PLANNING AND ZONING COMMISSION REGULAR MEETING AGENDA

Wednesday, May 13, 2020 6:30

- 6. Conduct a public hearing upon a Preliminary Plat for Lagos Subdivision Phases 2 4, three hundred fifty-three (353) lots on 96.06 acres more or less, and being located near N FM 973 and Brenham Road, Manor, TX.

LAGOS PHASES 2-4 CITY OF MANOR, TRAVIS COUNTY, TEXAS

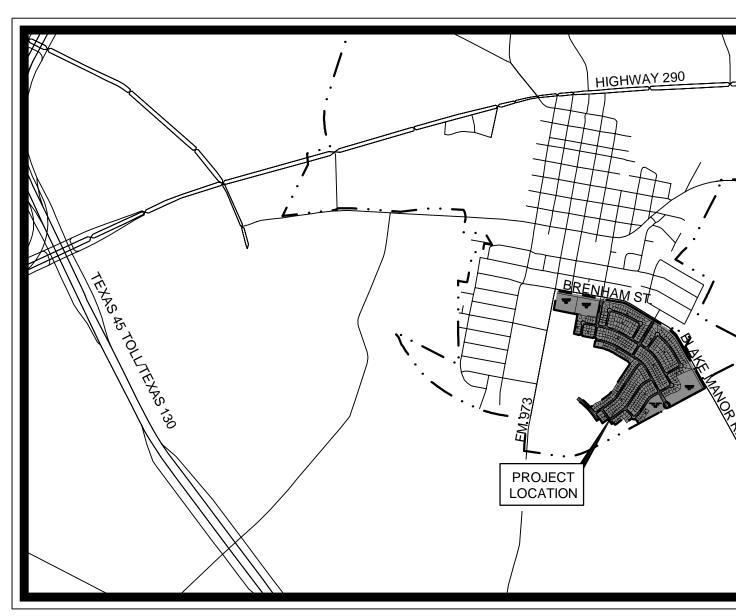
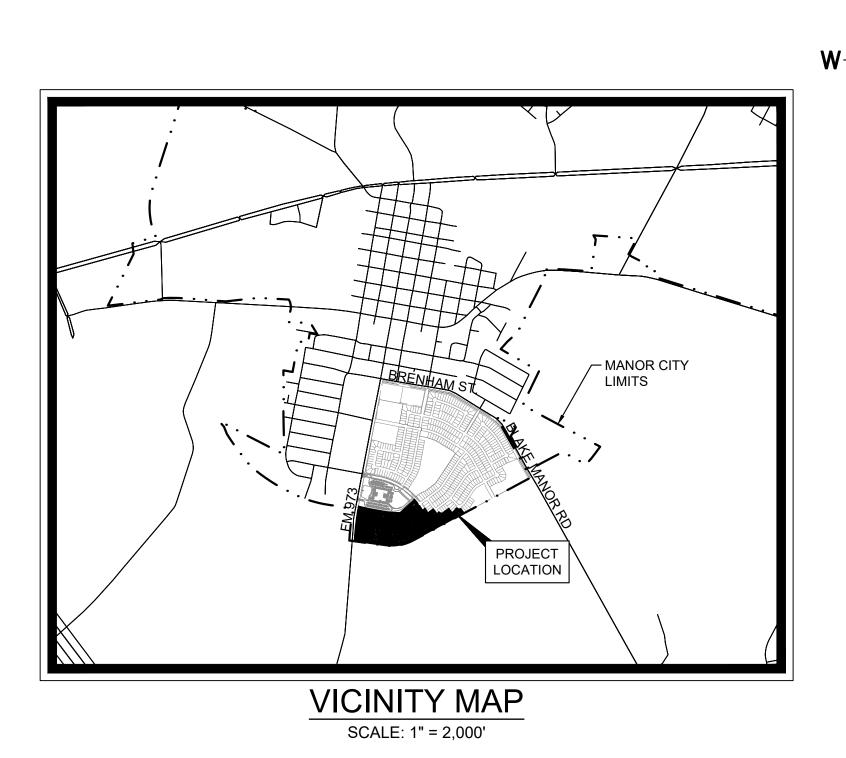
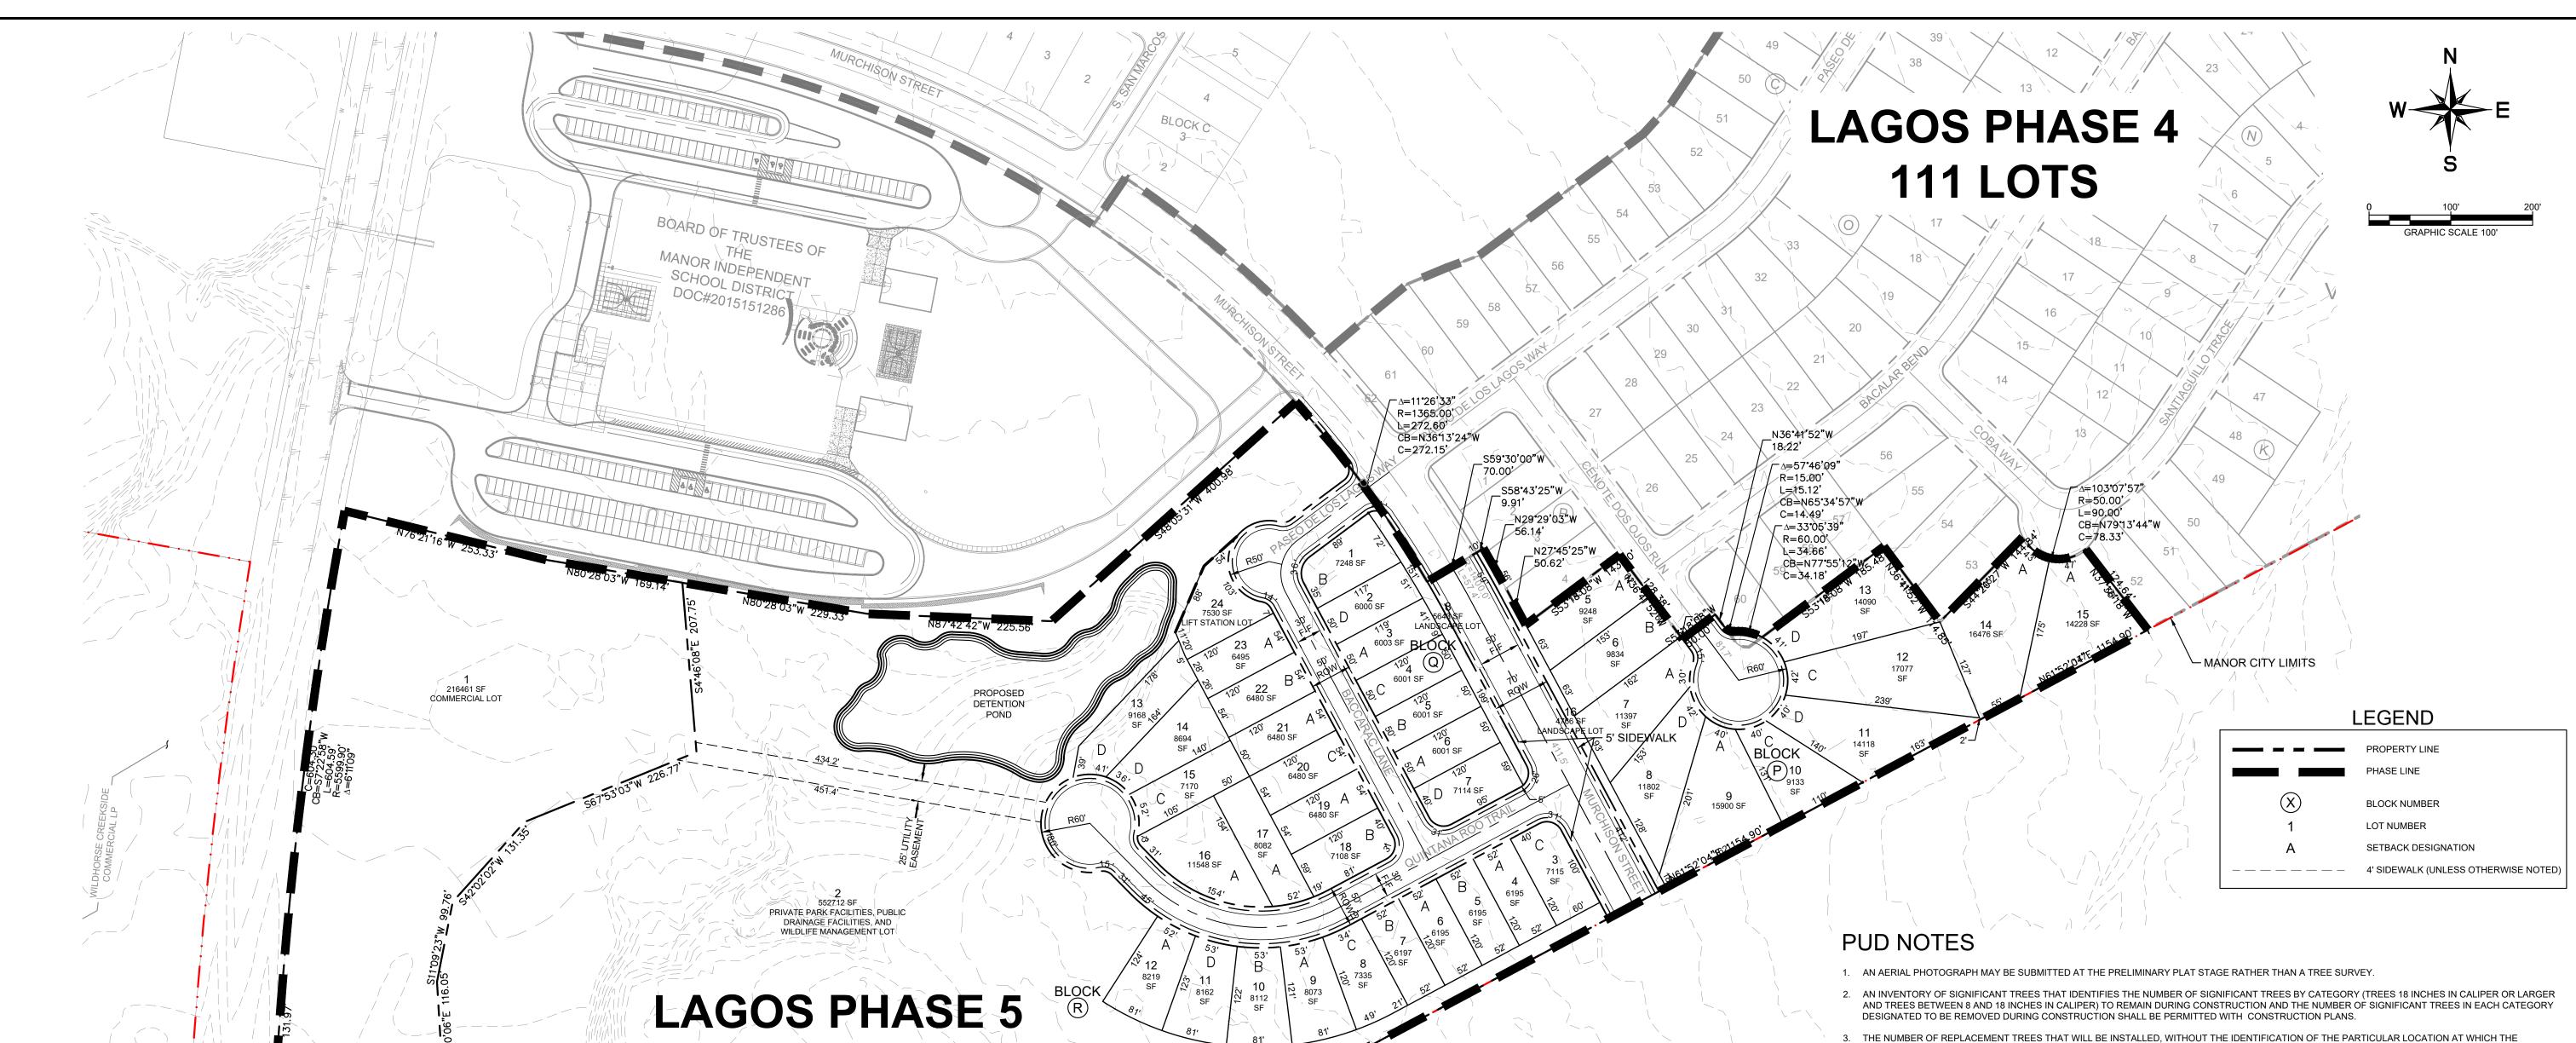
- 1. Mailing labels should be provided for property owners within three hundred (300) feet of the subdivision boundary.
- 2. On Sheet 2 of the submittal there is a label for 213' r.o.w. dedication near the intersection of Street A and E Brenham Street. It is unclear what is proposed for this area.

- 3. On Sheet 2 there are lots located near Lot 45 Block K that are marked differently. Clarification should be made as to what is being shown for those lots.

- 4. Section 22(c)(2)(i) of Subdivision Ordinance 263B requires that the existing property lines, including bearings and distances be shown.
- 5. On Sheet 8 there is a label for an 8" waterline, but no waterline is shown (near the intersection of Street A and E Brenham Street). There is also a fire hydrant shown that is not on a waterline.

- 8. The Parkland Table on Sheet 3 should be verified. No required parkland was calculated. The Lagos Parkland Table should also be verified.
- 9. The Parkland Table lists 0.94 acres of parkland for Phases 2-4. The proposed parkland lots should be clearly labeled.

- 10. On Sheet 8 the stub outs for the future commercial sections should be labeled.
- 11. On Sheet 10 the forcemain should be shown in bold since it is proposed with this project.

- 12. On Sheet 11 stub outs for the future commercial should be labeled.
- 13. On Sheet 13 the sizes of the existing culverts and drainage swale should be labeled as is required by Section 22(c)(2)(iv) of Subdivision Ordinance 263B.14.

- 15. On Sheet 16 clarification should be made as to what is existing and what is proposed for the storm sewer lines that drain into the pond. Also, the storm sewer line does not line up with the storm sewer line and headwall shown on the northern part of the existing pond.

- 16. On Sheet 16 there is a label for Street N that is not in the correct place.
- 17. The lot numbers on Sheet 16 do not match lot numbers shown on other sheets.

Response: The locations, dimensions, names, and description of all proposed streets are now shown, and shown on all sheets excluding sheets 12 & 13, which are PDF sheets of previous approvals.
